July 18, 2022

ADDENDUM #1
QUOTE 22-66-1620

For: Removal and installation of new flooring at the Forsyth County North & South Precincts

South Precinct Photos

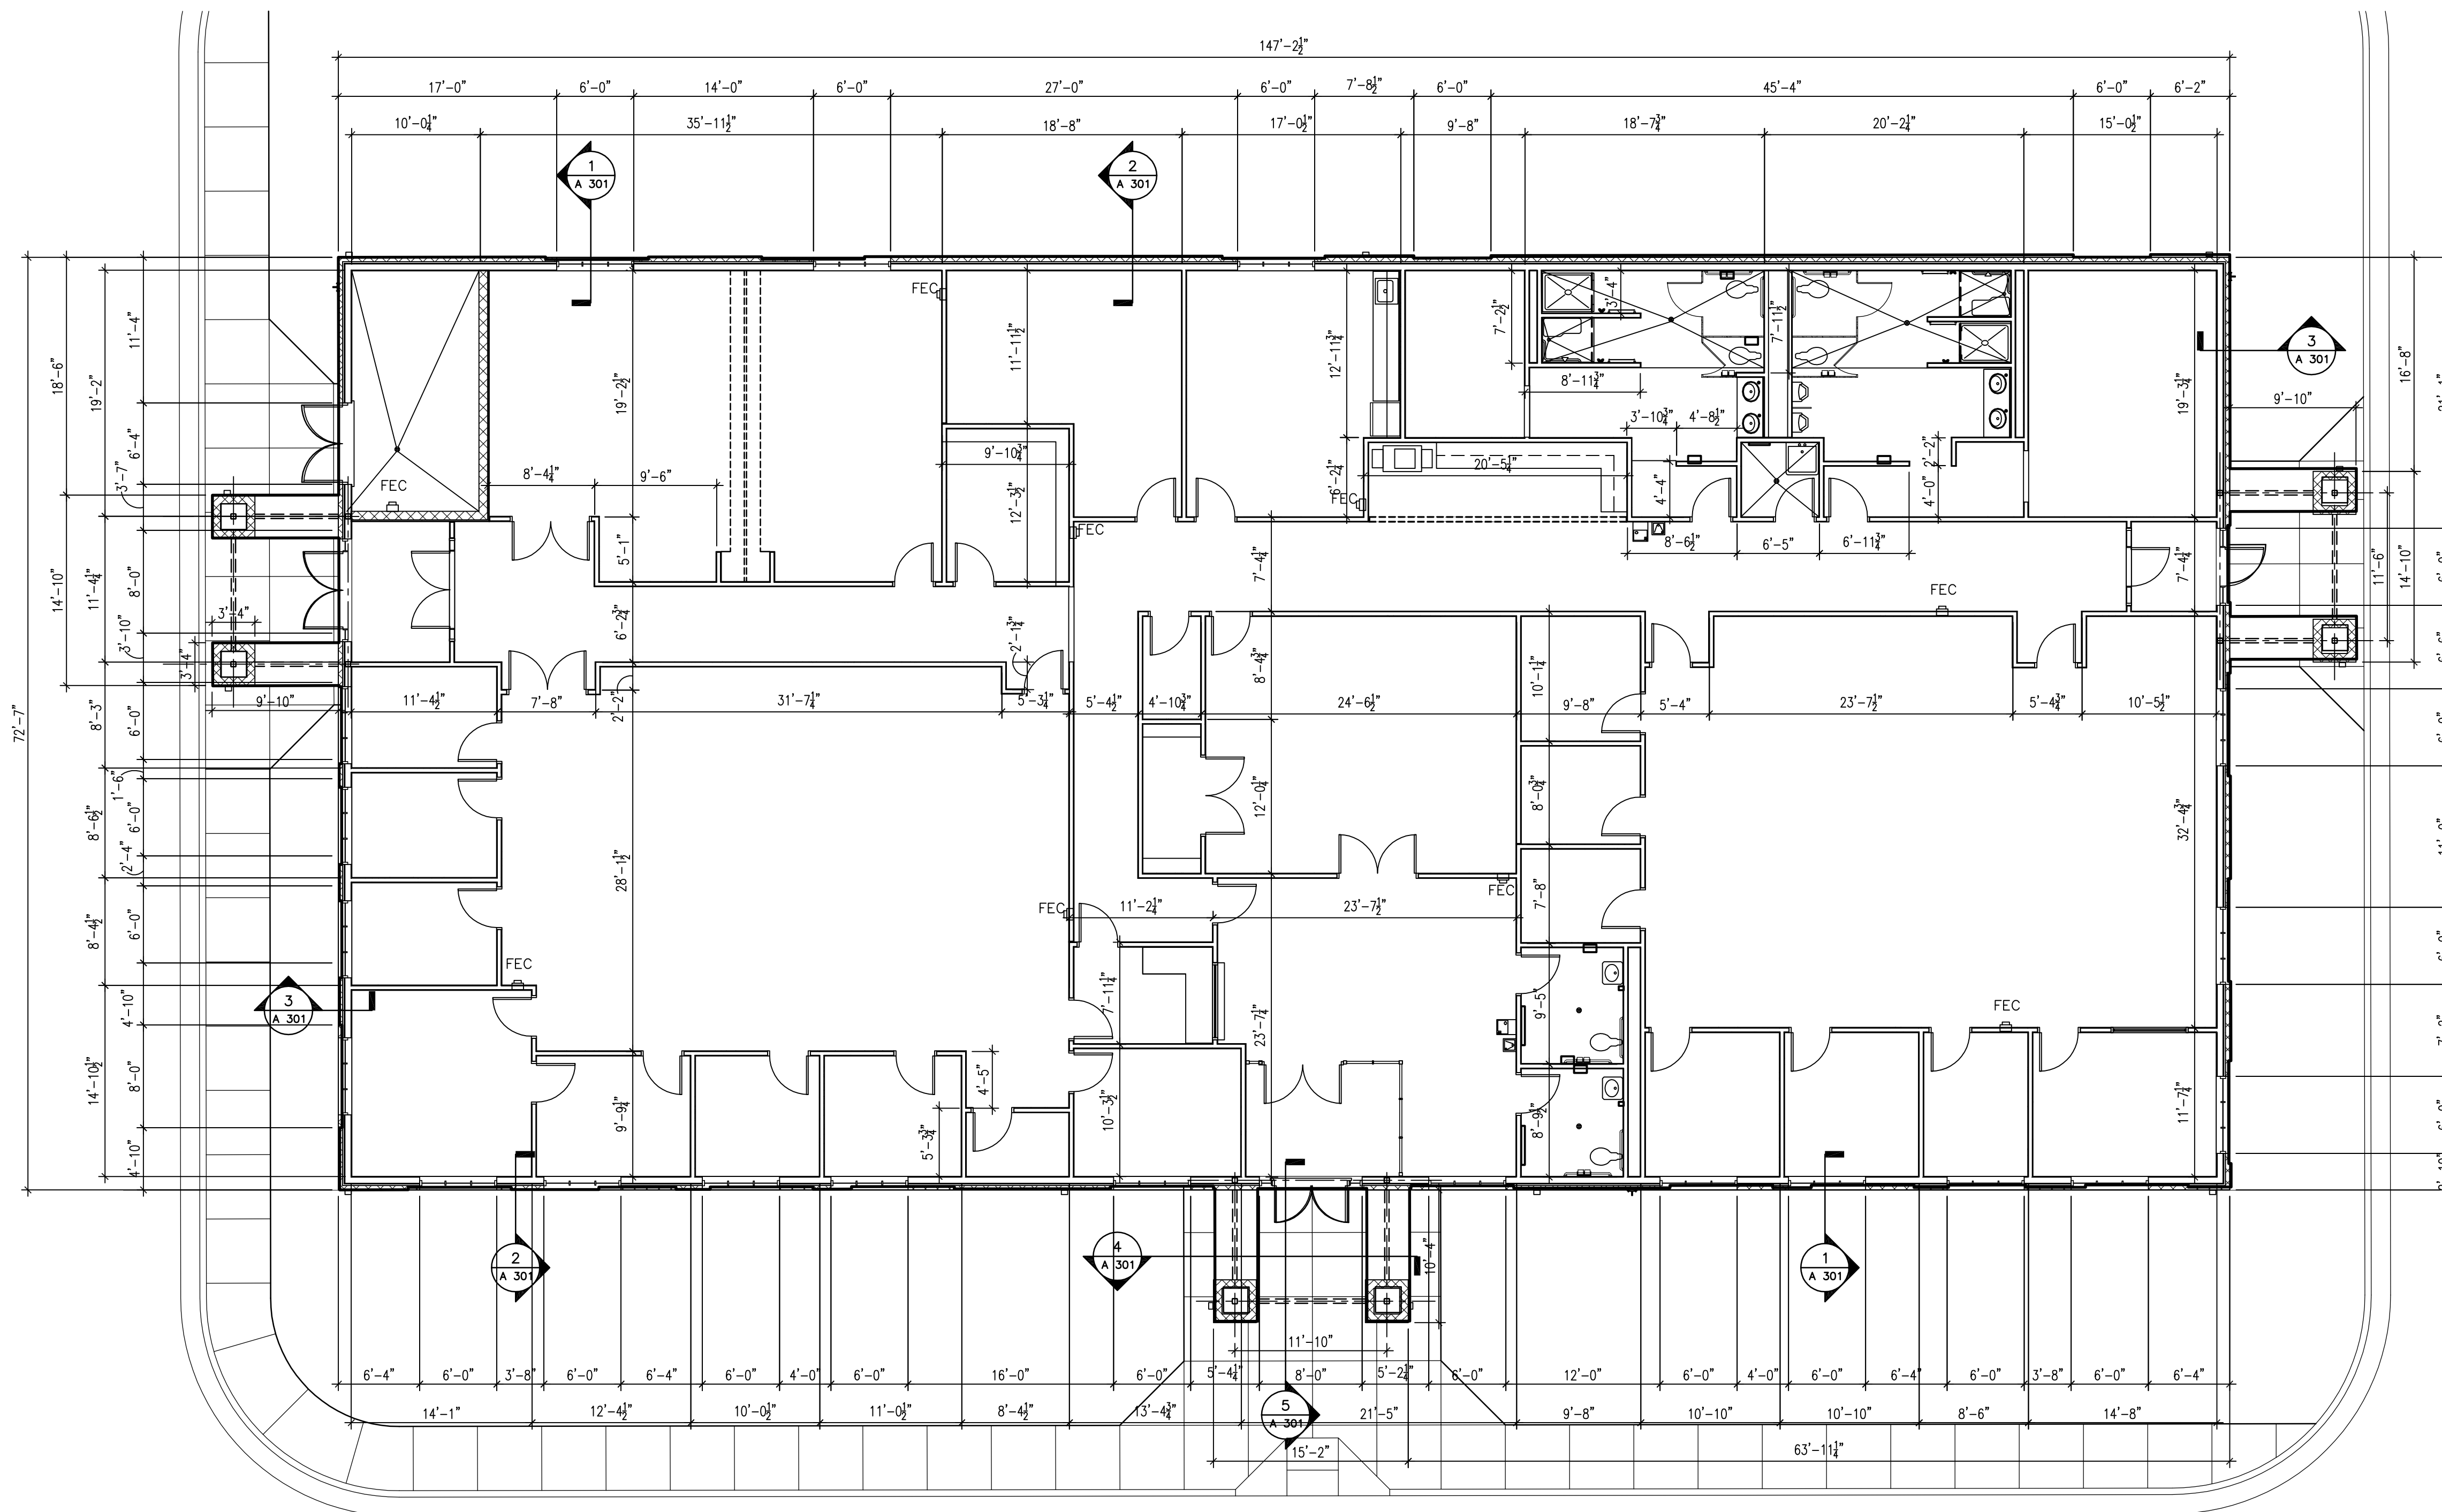
10. Can we please get a picture of the server room at the South Precinct?

Answer: Please see attached pictures.
